**VE (DI) FUEL-
INJECTION PUMPS**

**Workshop: EP
06.1994
0393 En**

Shutoff problems

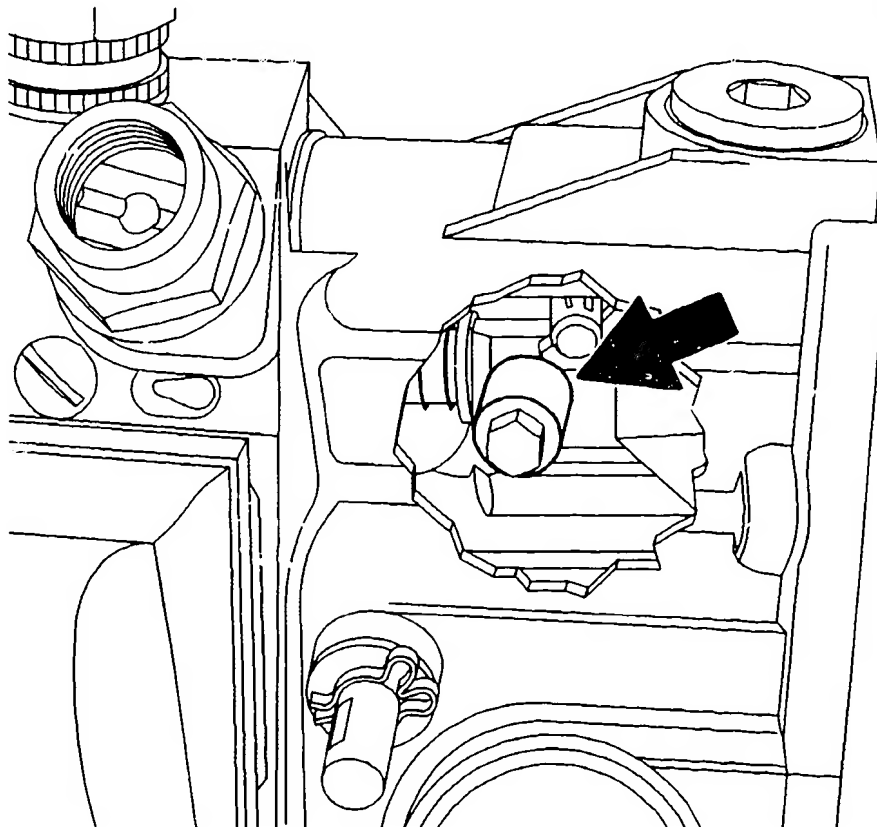
3. Replace torque link 9 421 080 683.
The new torque link must have a square 2 mm spacer (see illustration).

KMK05053

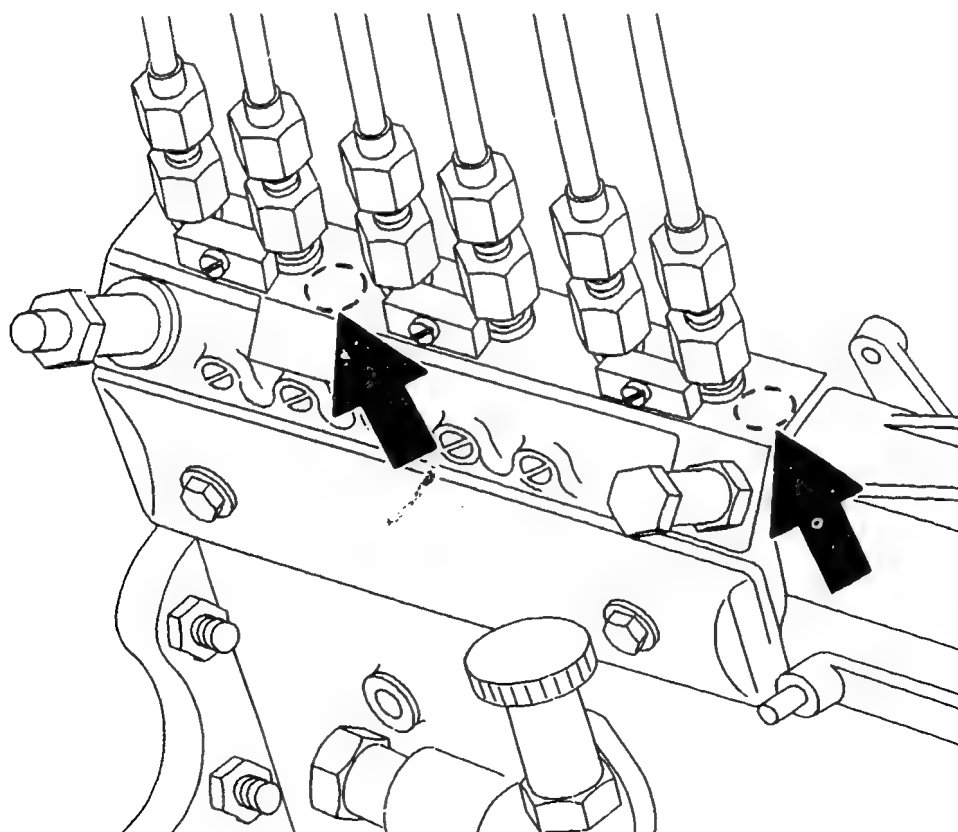
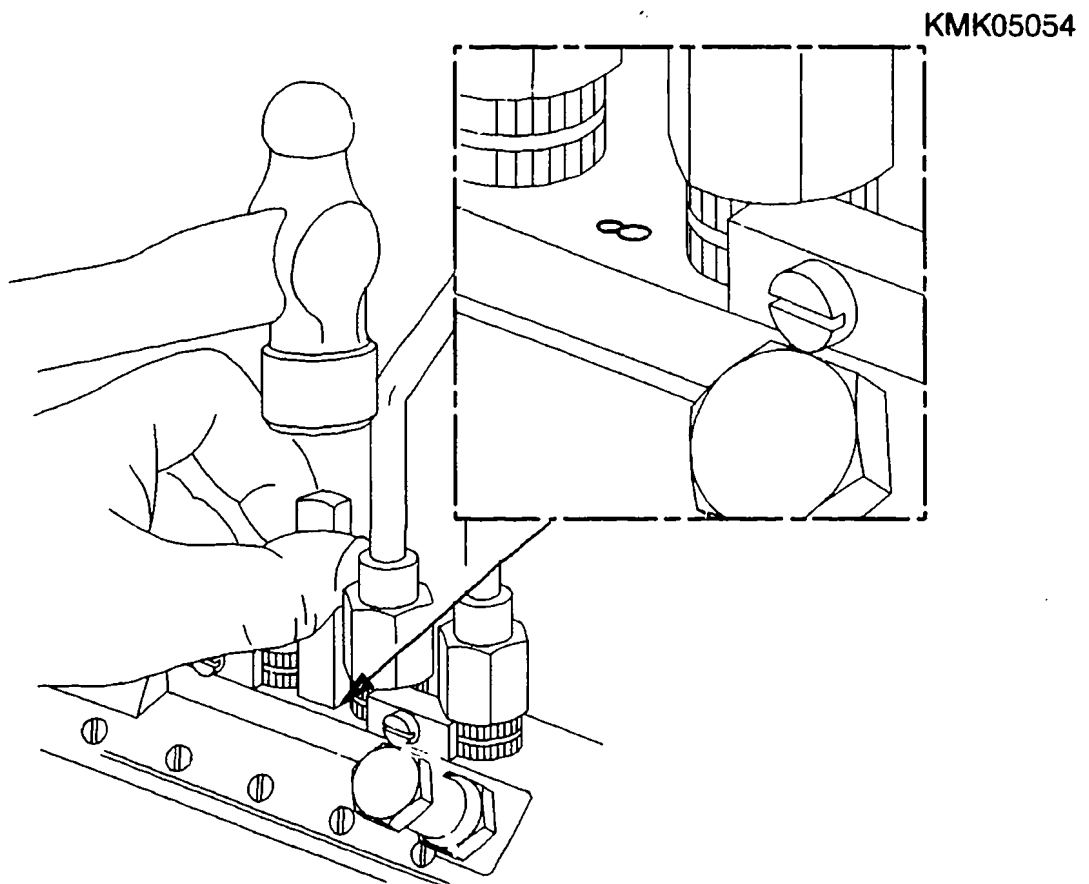
When you have completed the torque check or retorquing of the connecting bolt and nut, stamp the Number 8 between Cylinder Nos. 4 and 5 as shown in Illustration 4.

ARD ASSEMBLY

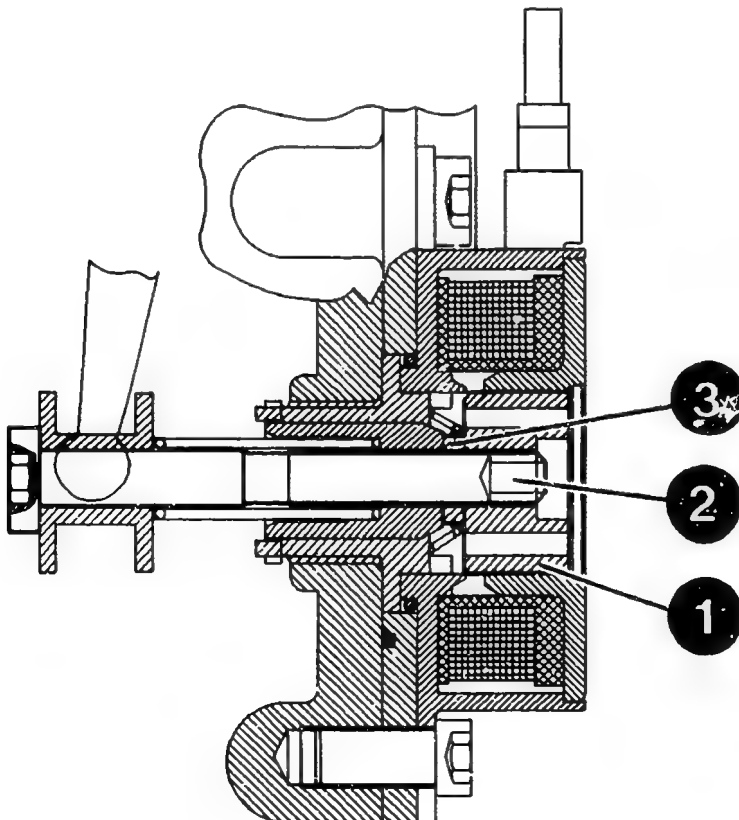
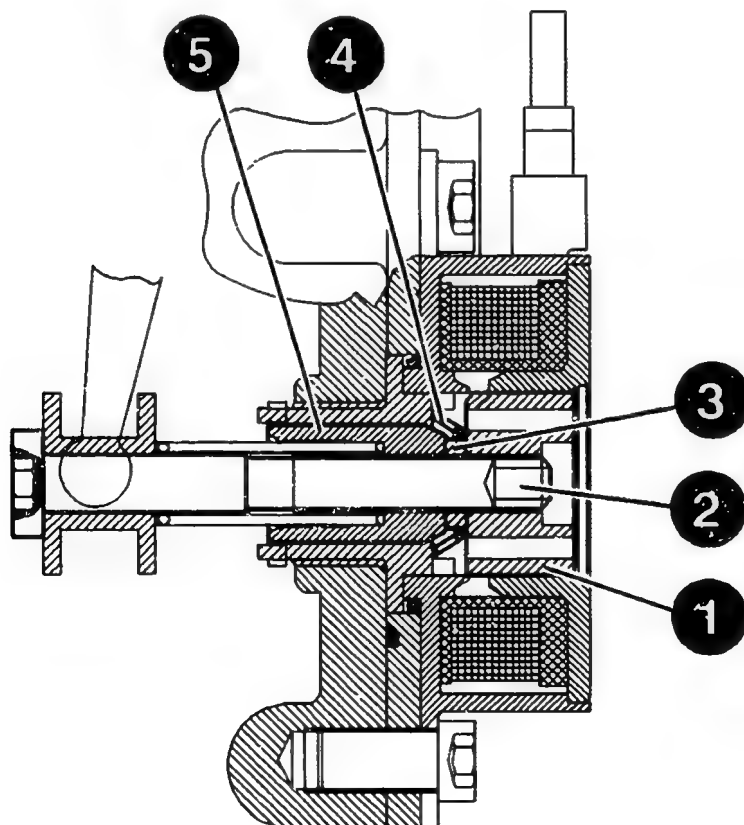
Remove ARD fastening screws.
Loosen armature with socket wrench
KDEP 1911 - G 986 612 599.
Whilst doing so, conterhold full-load
screw with 3 mm Allen wrench.
Remove return spring.
Remove shim, ARD stroke.
Replace shim removed (thickness of
shim 2.55 mm instead of 3.15 mm).

Insert socket wrench 0 986 612 599 in holes in armature and tighten to 5...7 Nm.

KMK04725

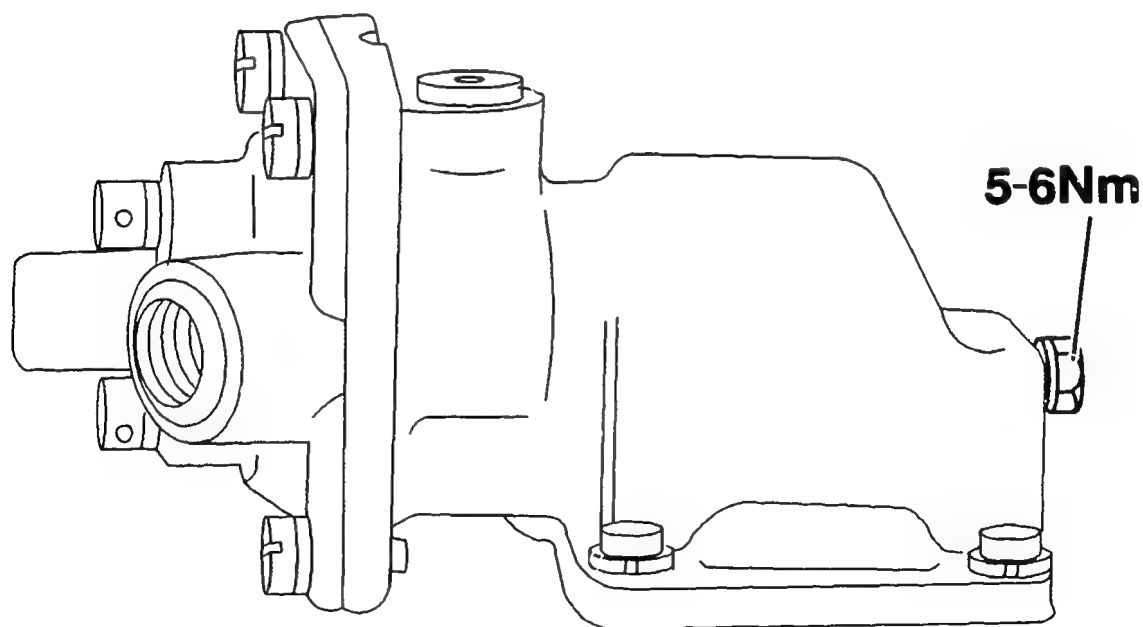
When performing starting fuel quantity adjustments on P-7100 injection pump combinations using top-mounted LDA assemblies, be certain to apply the correct torque to the locking screw and ensure that there is full movement capacity of the stop part after doing so. The specified torque of the locking screw is 5...6 Nm (see illustration).

KMK04726

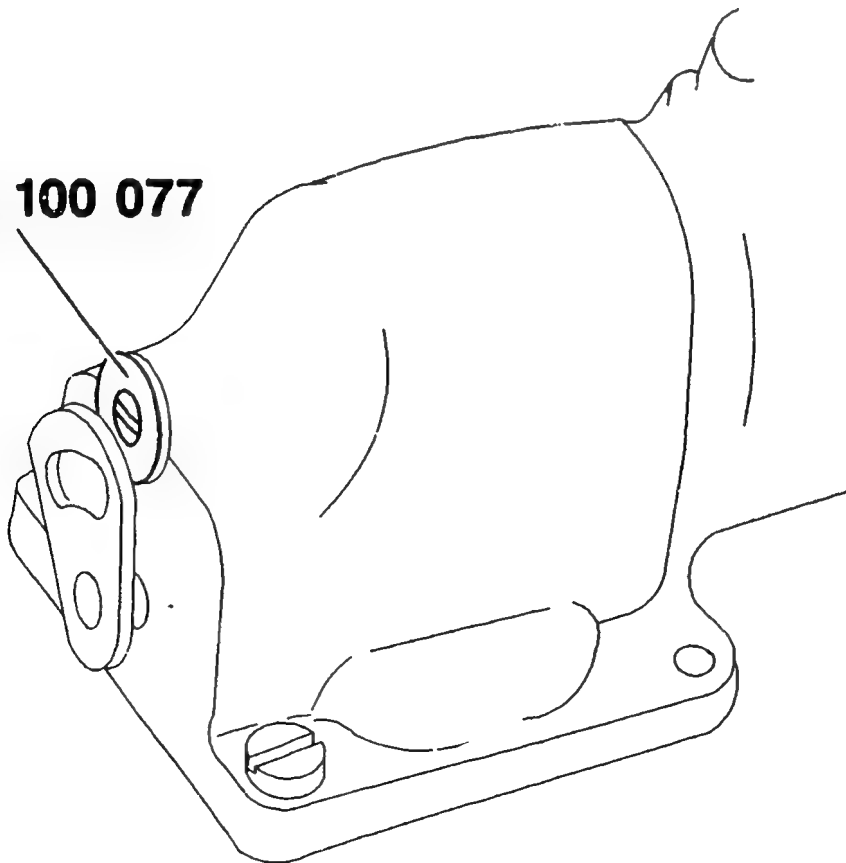
In the event that the stop part does not slide on the eccentric shaft when the setting screw is tightened, install a 0.5mm shim part number 2 420 100 077 between the adjusting quadrant of the shaft and the housing. Pass the screw threads through the center hole in the shim (see illustration).

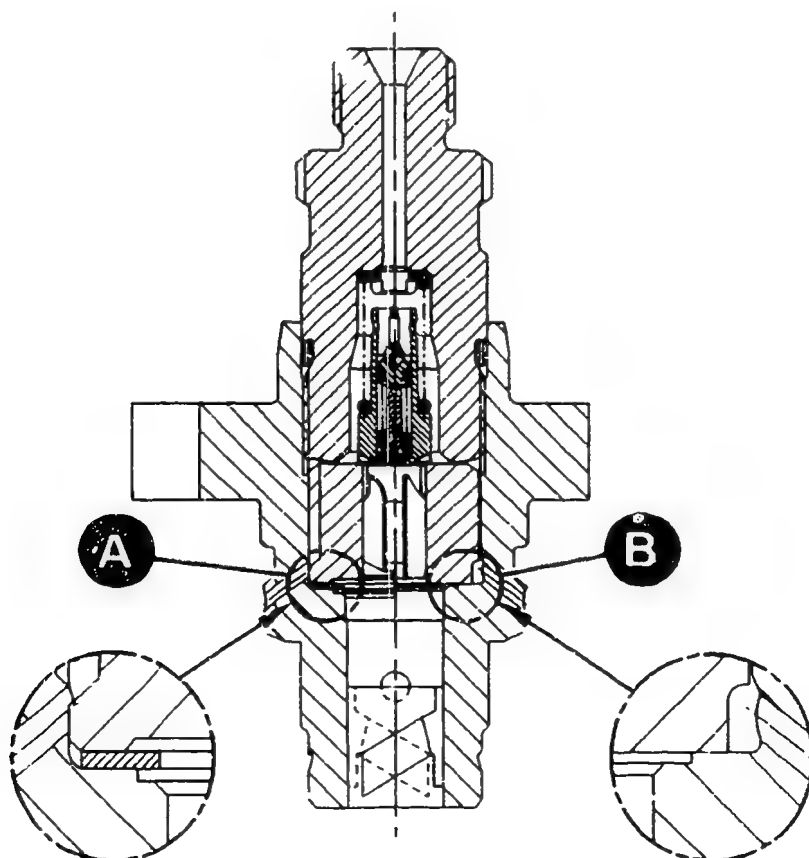
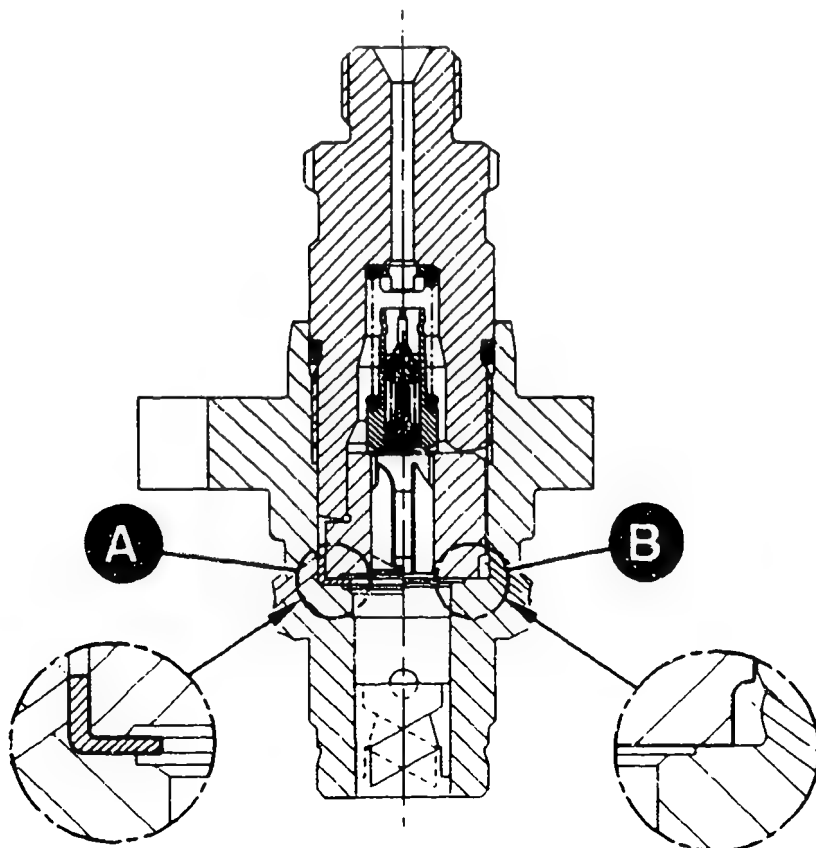
Arrow A - DV seal with sealing cap

Arrow B - "hard seal"

KMK03383

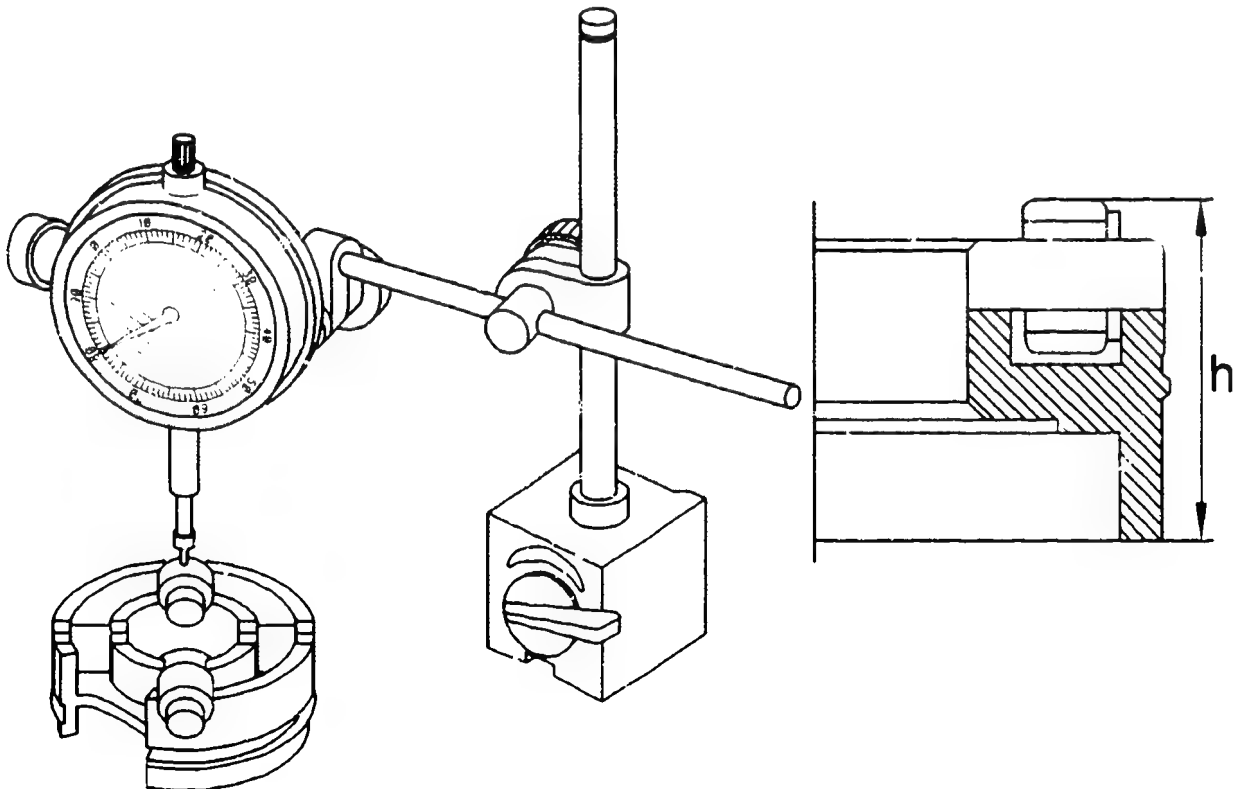
To date, the "cam roller ring" service parts assembly has only been quoted as a complete item in service parts lists and installed as an entity. Technology has now reached a level where it is possible to replace individual rollers, bushings and bearing pins.

* Maximum difference between individual roller heights 0.04 mm

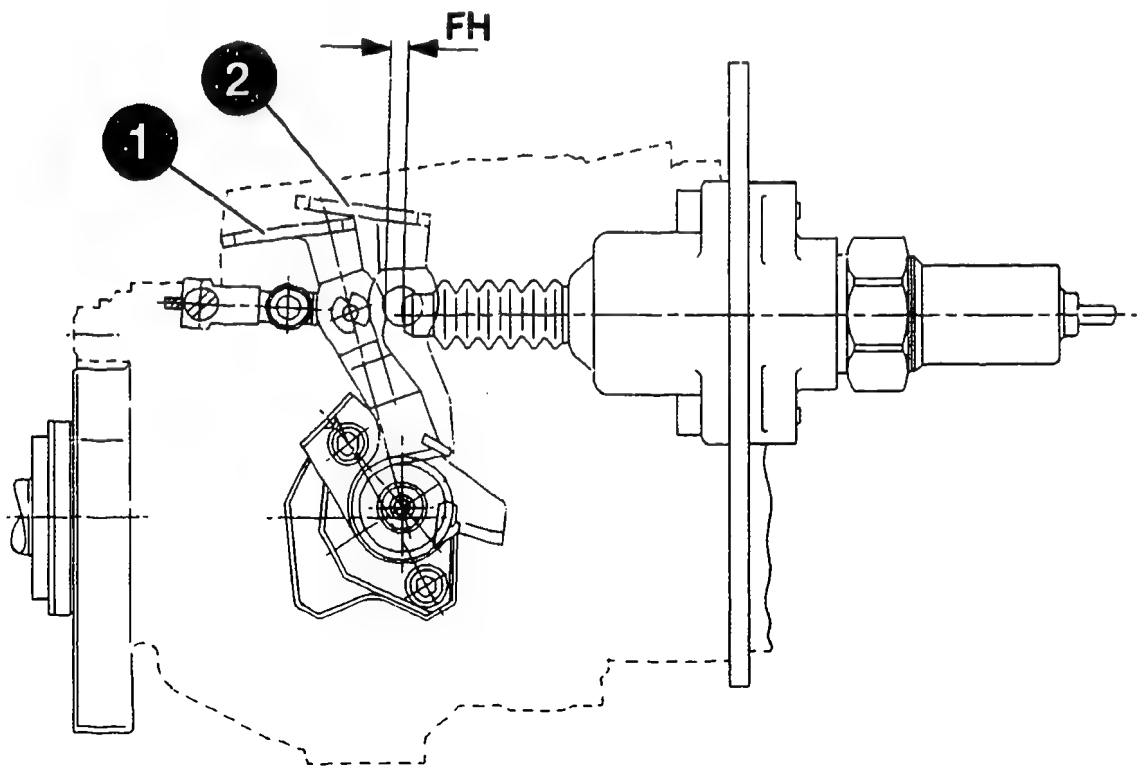
To improve cold starting problems, the adjustment travel of the cold start acceleration device acting on the roller ring is being altered from 7 mm to 2.9 mm.

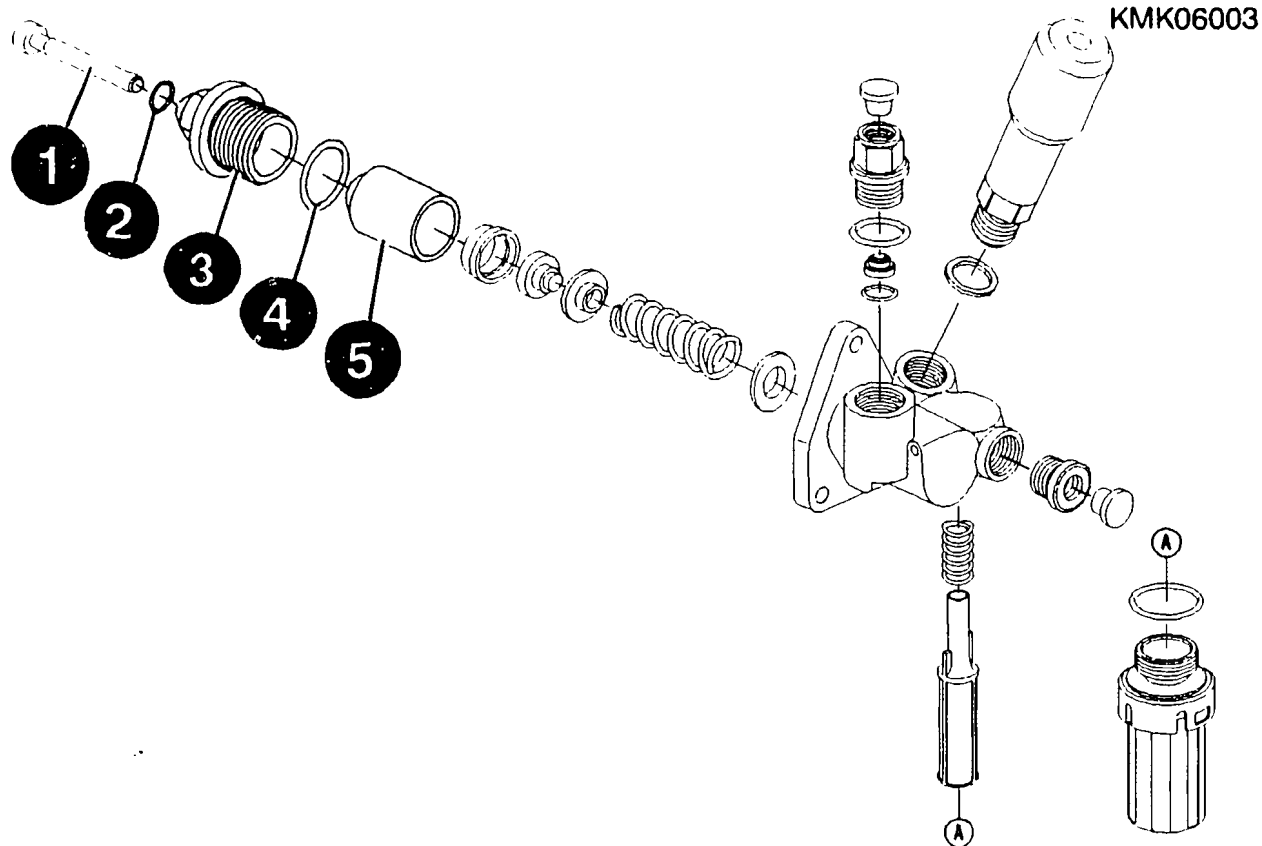
Without an O-ring fuel can ingress
into the pump and dilute the
lubricating oil.
